UNITED STATES PATENT AND TRADEMARK OFFICE

APPLICATION NO.	FILING DATE	FIRST NAMED INVENTOR	ATTORNEY DOCKET NO.	CONFIRMATION NO.
10/731,210	12/09/2003	B. Thomas Barker	4002-	4618

Office Action Summary

DETAILED ACTION

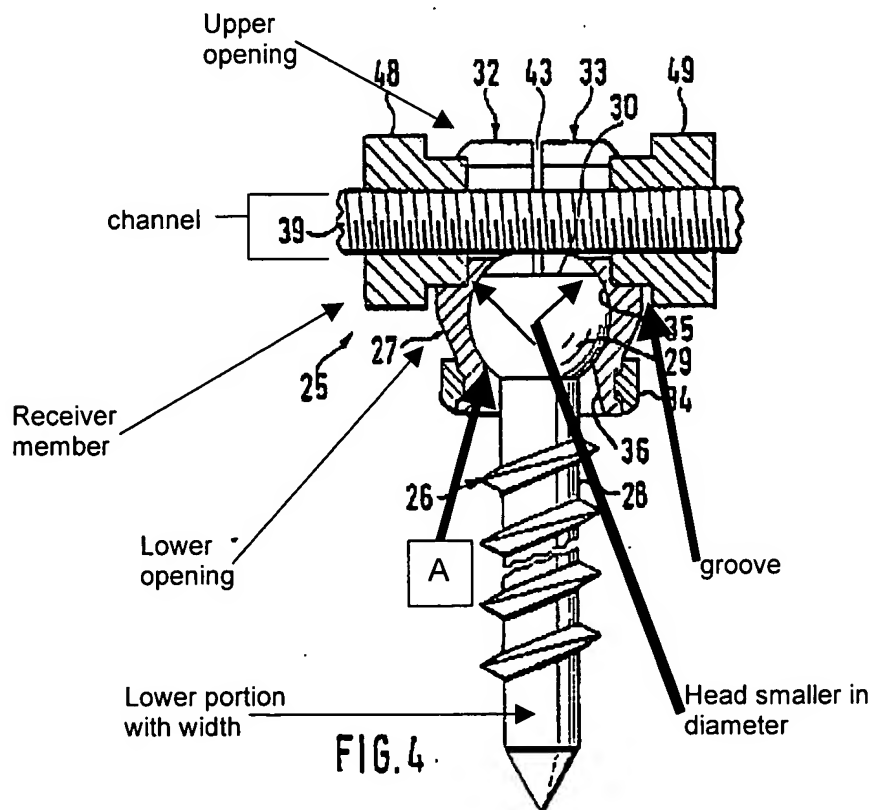
Claims 1, 2, 3, 20-23, 29-30, 36-38, 39-43 are rejected under 35 U.S.C. 102(b) as being anticipated by Harms et al. (U.S. Patent 4,946,458). Harms et al. discloses a bone anchor assembly having a receiving member, having an upper opening, a lower opening, a channel configured to receive an elongated member, and a groove around the lower portion of the receiving member. See FIG. 4 below.

Harms et al. also discloses a bone engaging anchor (e.g. a bone screw) that has a lower portion having a width (see Fig. 4), a head (29) that has a width smaller than the lower opening portion (see Fig. 4), a retaining member with a diameter smaller than the head and positioned below the head (see item A, in Fig. 4 above) and that is partially housed in the groove of the receiver member (see item labeled "groove" above). Harms et al. further shows a compression member with two branches (items 48 and 49 above) capable of securing an elongated member (e.g. a rod--39), and a crown member that can be considered beveled and concave that defines a hole through the apparatus. (See. Fig. 9). Being beveled and concave implies that a hole is present to acquire that shape.

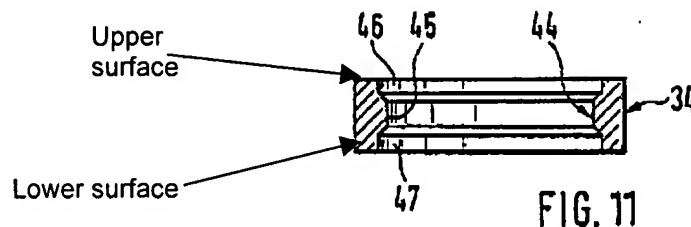
Harms et al. also discloses a crown member (34) that is movably disposed having an upper and lower surface (See FIG. 11).

Item 36 is beneath crown member 34. This figure shows the rounded, beveled shape that creates a hole. Since the crown surrounds item 36, it must have the same shape.
